## Department of Planning and Environment

Our ref: OUT22/5495

**Subject: Dendrobium Mine Extension Project (SSI-33143123) – Environmental Impact Statement (EIS)**

### Detailed Licencing and Approvals advice to DPE Planning & Assessment regarding the Dendrobium Mine Extension Project (SSI-33143123) – EIS

**Figure 1 – Groundwater Monitoring (ref: Appendix B Groundwater Assessment)**

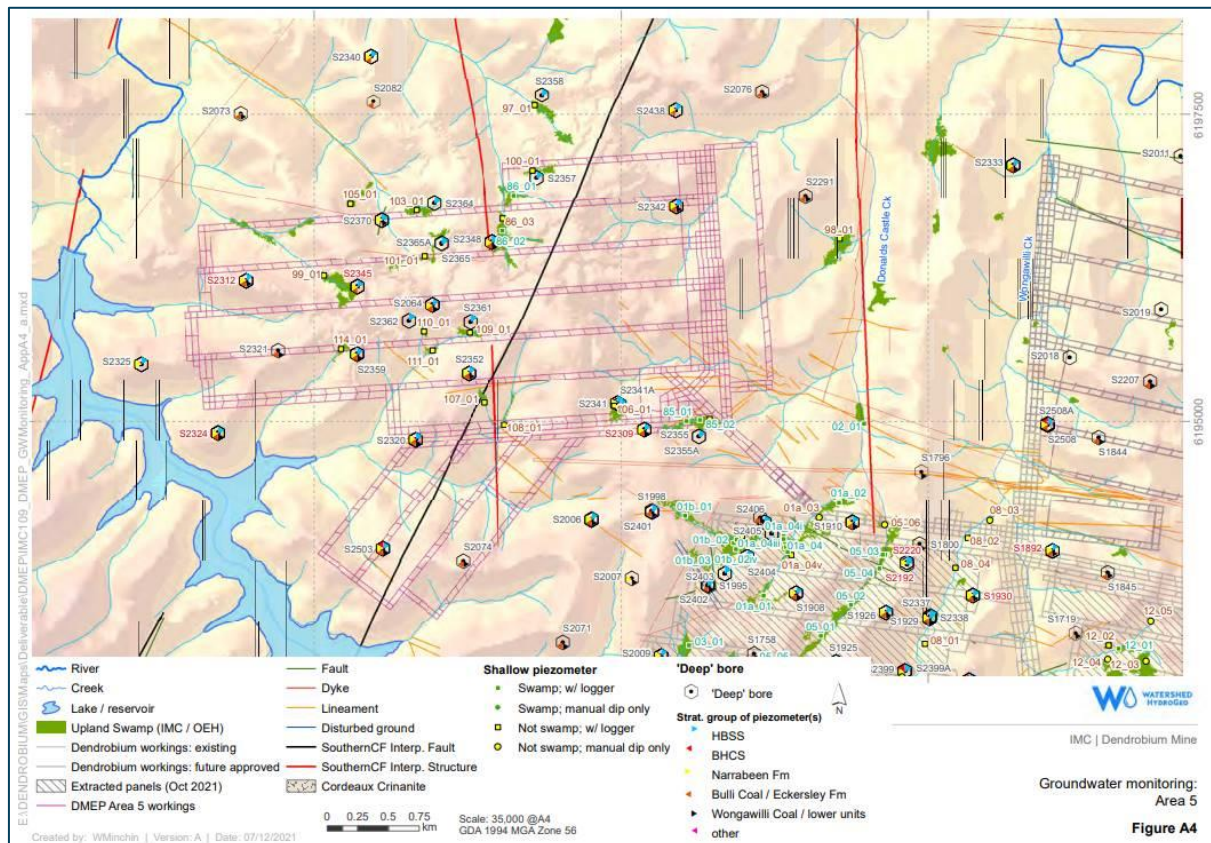
It is reported that the deeper Permian geology has saline groundwater, whilst the groundwater in the shallower Triassic Hawkesbury Sandstone is relatively fresh. Post mining groundwater re-equilibration predicts upward movement of groundwater from the Permian to the Triassic. The proponent asserts that mixing of waters would be acceptable however no evidence is provided to support this conclusion.

There is an interpreted fault (called 'SouthernCF Interpreted Fault' – see Figure 1 above which is Figure A4 in Appendix B) feature that passes directly through the centre of Area 5 and under the Avon Dam reservoir. This relatively large fault feature has not been investigated to assess its transmissive capacity and how subsidence may alter the capacity of the fault to be a water conduit. If it does behave as a water conduit, it may be able to transfer poor quality water from the deeper Permian geology to both the Avon Reservoir and Hawkesbury Sandstone. The proponent seeks to defer any assessment of this fault feature until the post-Approval Extraction Plan stage. Such a fault feature poses considerable uncertainty in estimating the range of take given its connection with the Avon Reservoir, and the re-distribution of poor quality water due to mining.

- c) Assess the transmissive capacity of the interpreted fault passing centrally through Area 5, and discuss the associated potential impact to water quality and water level changes.

**Figure 2 - Extent of iron in DA3 mining operations (ref: Dendrobium Area 3B, Illawarra Metallurgical Coal Impact Report 9 August 2021)**

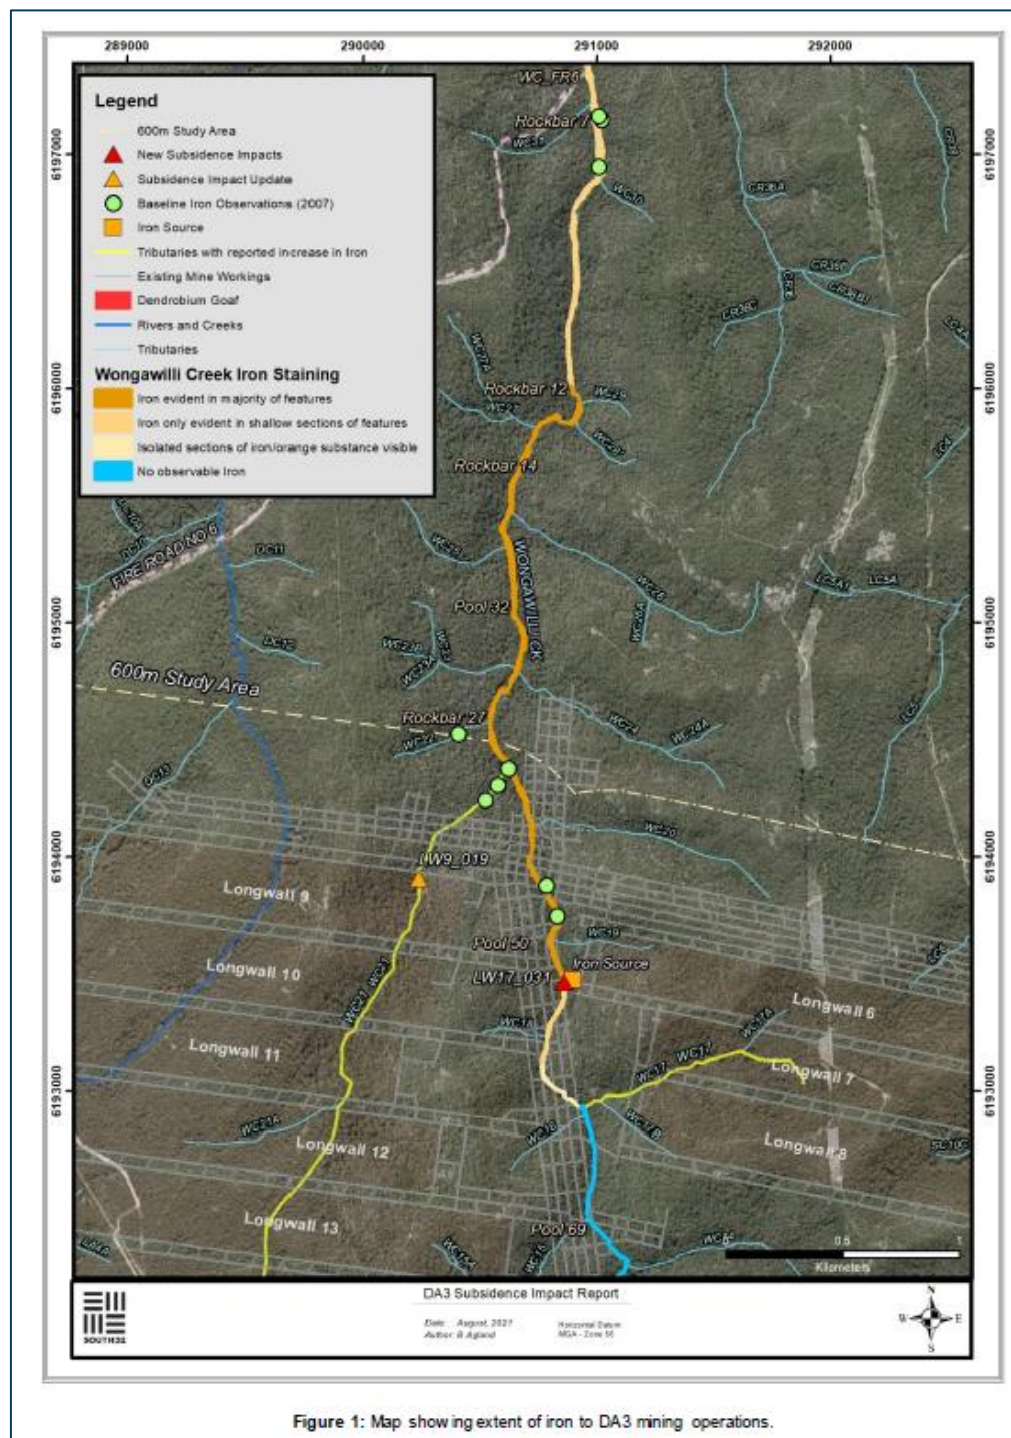
The end of longwall panel (LW 18) report 'Dendrobium Mine Iron-staining in Wongawilli Creek' (Illawarra Metallurgical Coal, August 2021) identified the extent of iron related impacts within Wongawilli Creek. It is evident from Figure 1 above that significant water quality deterioration is occurring within Wongawilli Creek and tributaries. It should also be noted that no secondary extraction was undertaken beneath Wongawilli Creek, this being the main water course separating areas 3A and 3B. The longwall panels viewed in Figure 1 of 3A and 3B, like Area 5, are beneath 1st and 2nd order streams as is proposed under the current Project. That is, current water quality impacts aren't constrained to 1st and 2nd order streams where longwall mining occurs, but is propagating to the main water courses regardless of the main water course not being undermined.

These water quality impacts are possibly driving a change in the beneficial use category of the groundwater resource. A statistical overview of P50 and P95 trace metal concentrations is not sufficient evidence to demonstrate that the groundwater quality will not deteriorate to a lower beneficial use class.

**Figure 3 - Hydrology and groundwater dependent features (ref Appendix B Groundwater Assessment).**

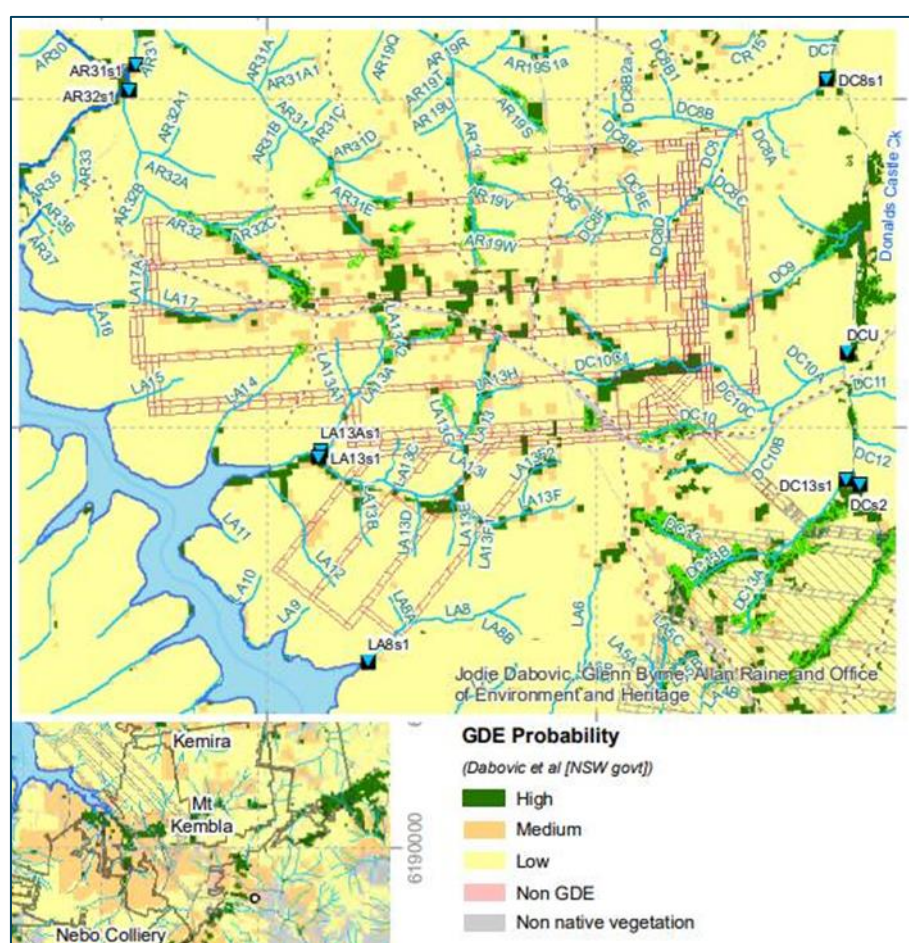
- (i) water quality; and
- (ii) drawdown at High Priority Groundwater Dependent Ecosystems, noting that proposed High Priority GDEs will be formally exhibited from late June 2022 as part of the draft remake of the Water Sharing Plan for the Greater Metropolitan Region Groundwater Sources. These proposed High Priority GDEs encompass the upland swamps overlying and in proximity to the Project.
